MISSISSIPPI DEPARTMENT OF TRANSPORTATION

SECTION 904 - NOTICE TO BIDDERS NO. 3502

PROJECT: BR-0009-01(132)/107176301 - WILKINSON

ADDENDUM

△ REVISED CALLOUTS / QUANTITIES

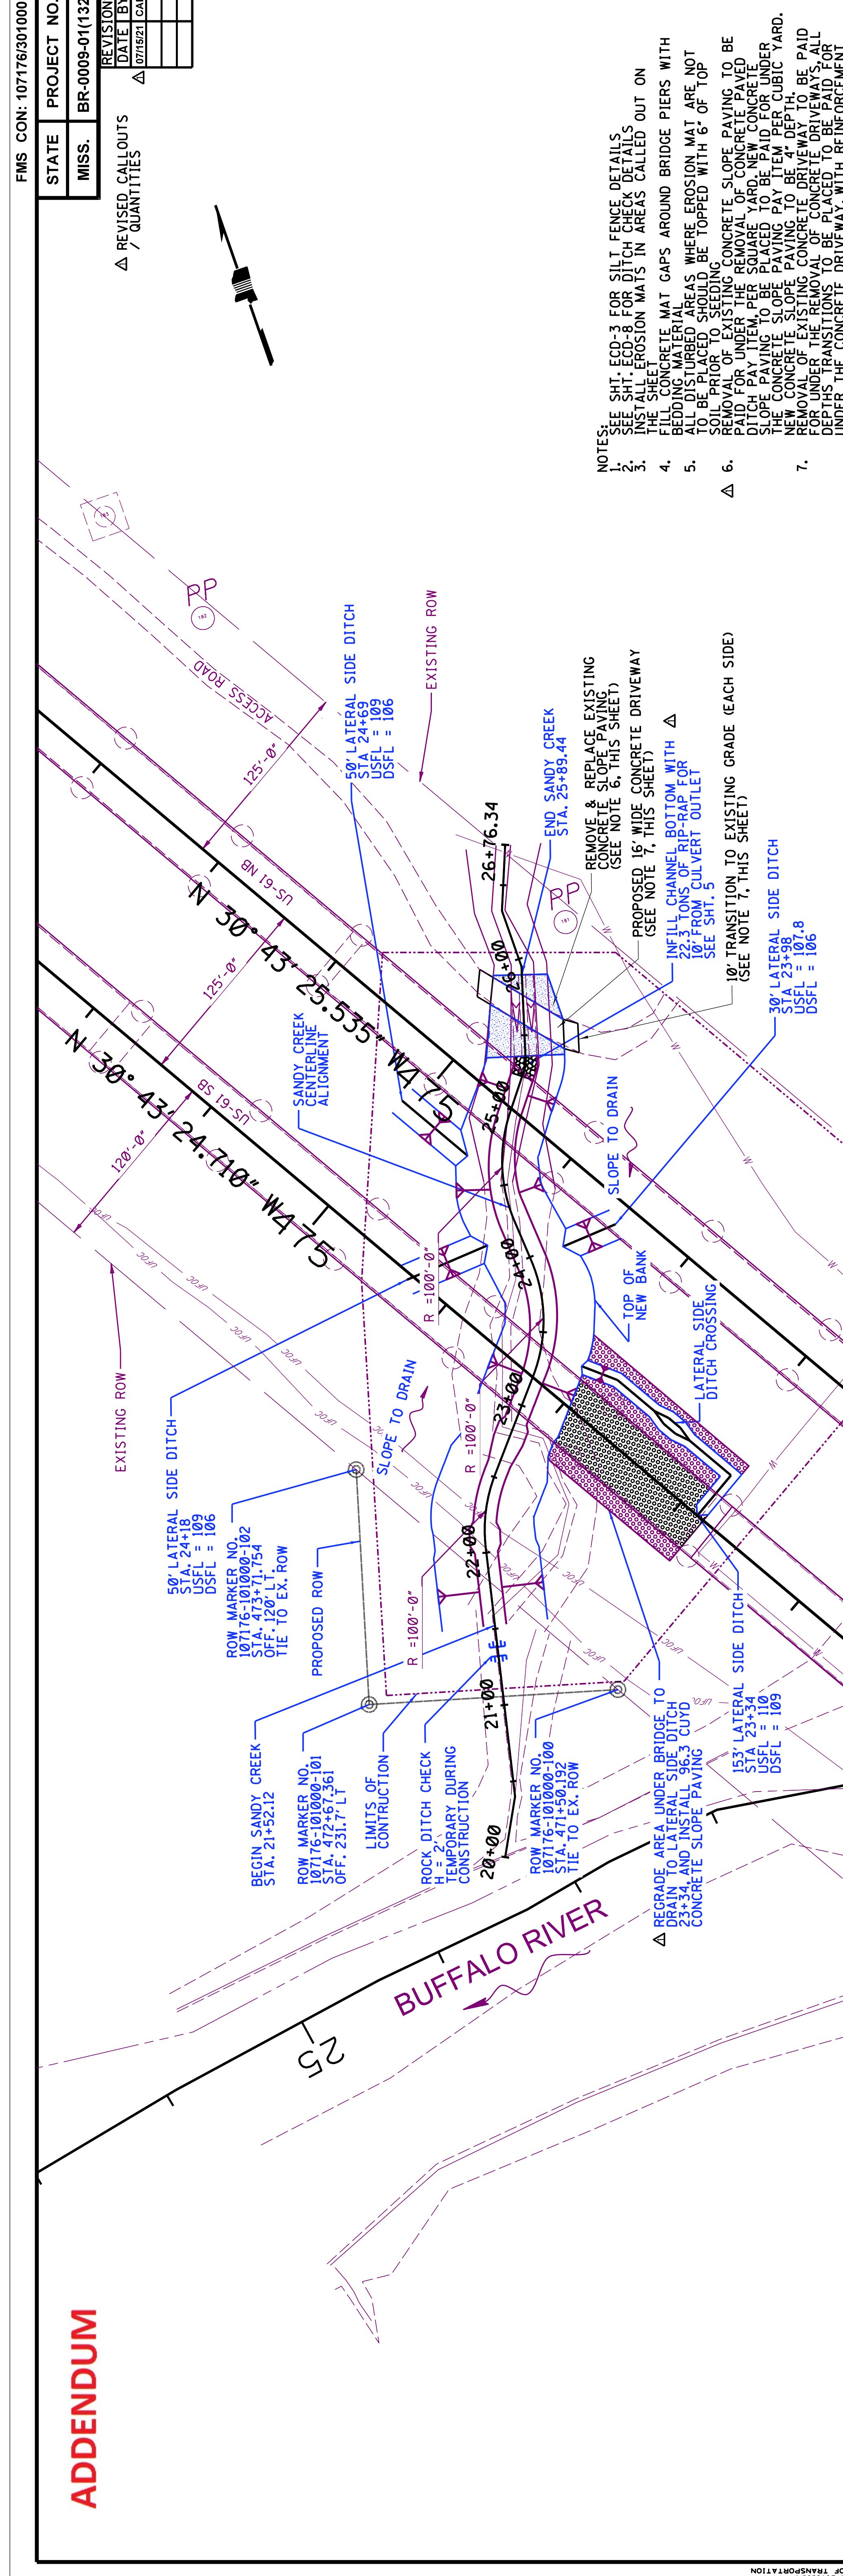
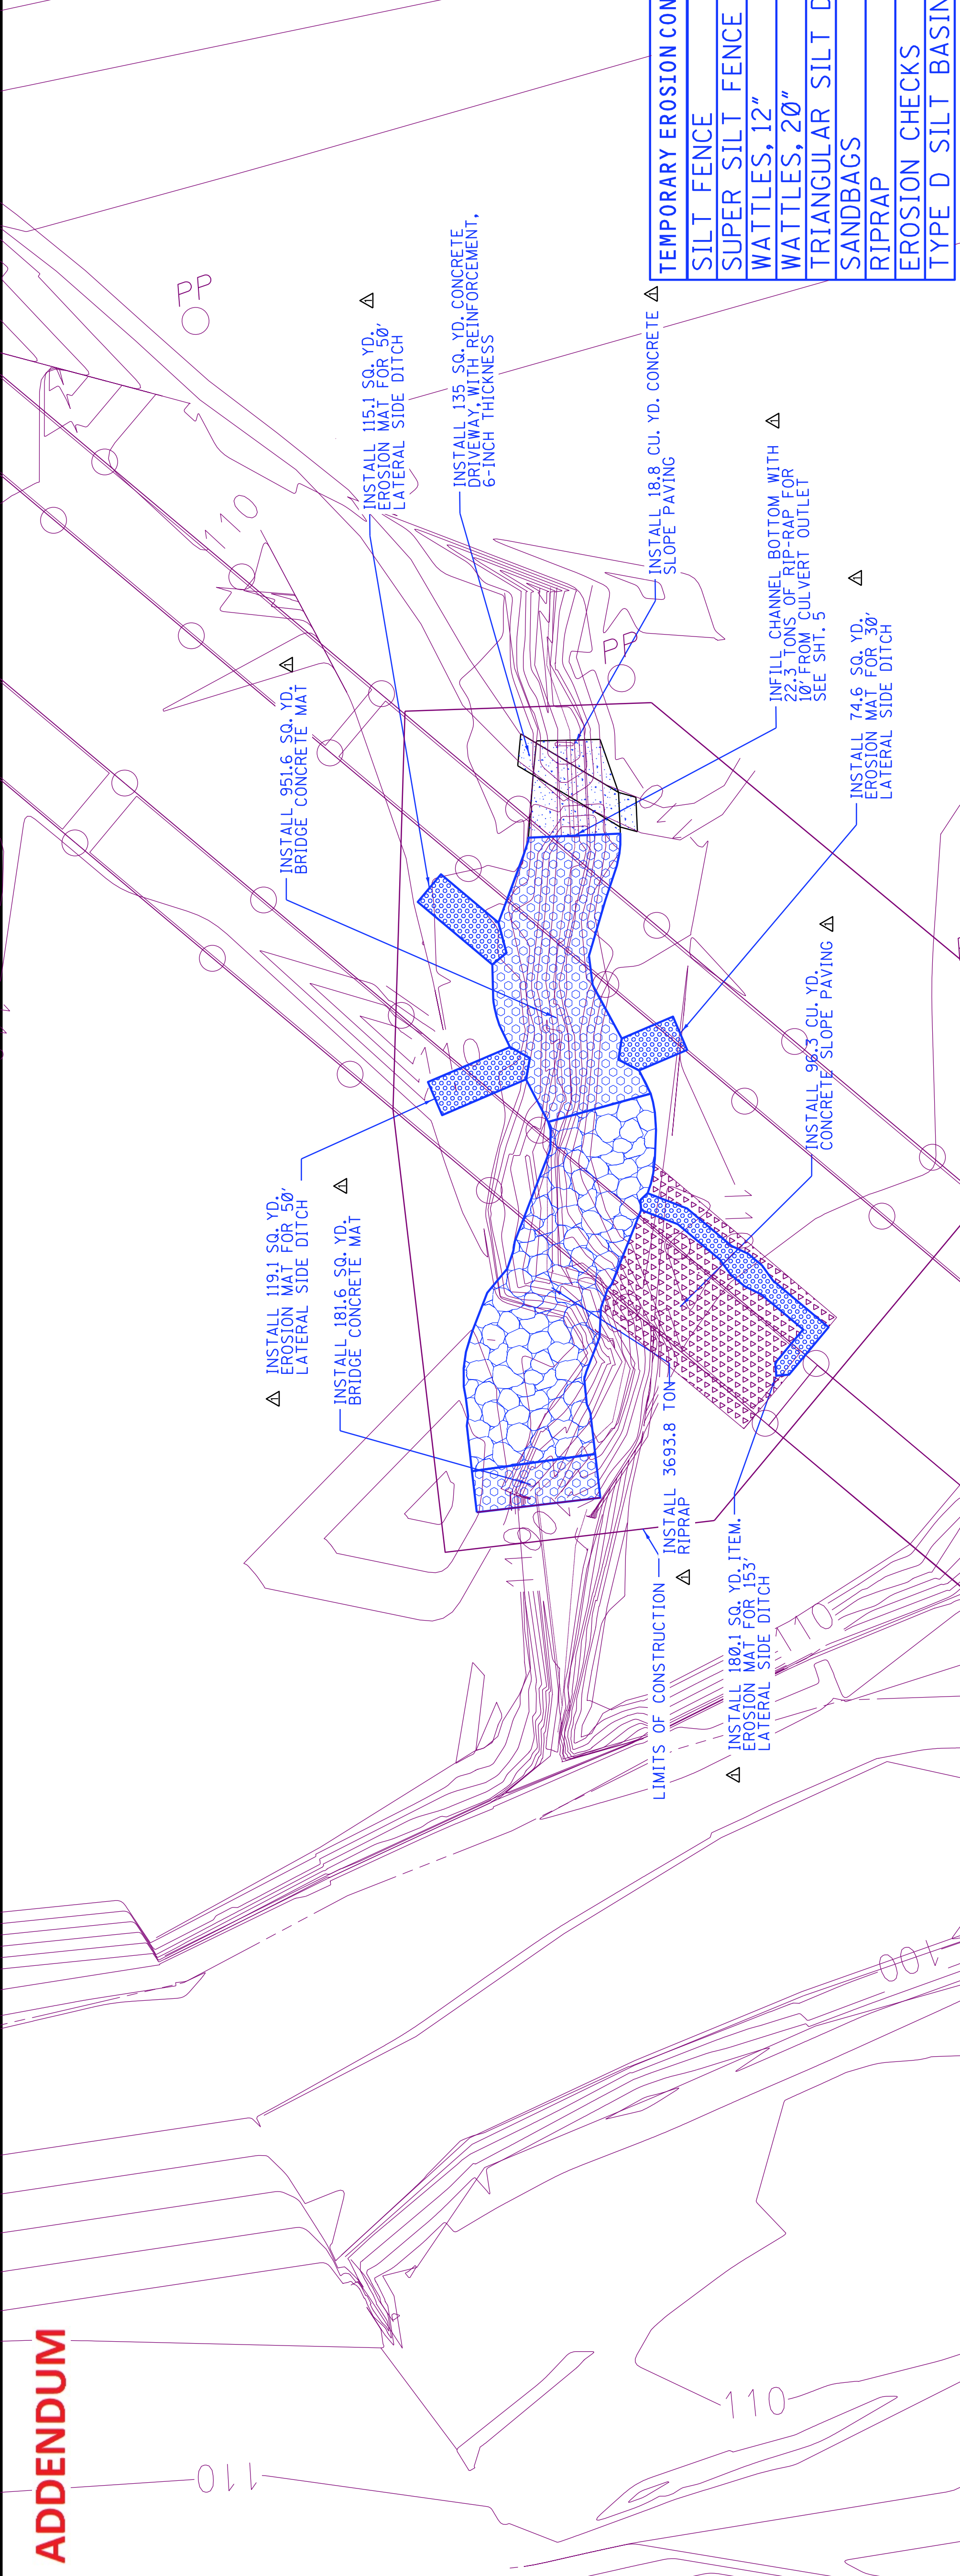
PERMANENT EROSION CONTROL ITEMS	UNITS	SYMBOL	TOTALS
BRIDGE CONCRETE MAT	S.Y.		1133.2Δ
EROSION MAT	S.Y.		488.9Δ
CONCRETE SLOPE PAVING	C.Y.Δ		115.1Δ
RIPRAP	TON		3716.1Δ
GEOTEXTILE	S.Y.		3043.5Δ
SOLID SOD	S.Y.		Δ
LEGEND			
	PROPOSED ROW		
	PERMANENT EASMENT		
	WATER LINE		
	UNDERGROUND FIBER OPTIC CABLE		
	POWER POLE

REVISED CALLOUTS / QUANTITIES
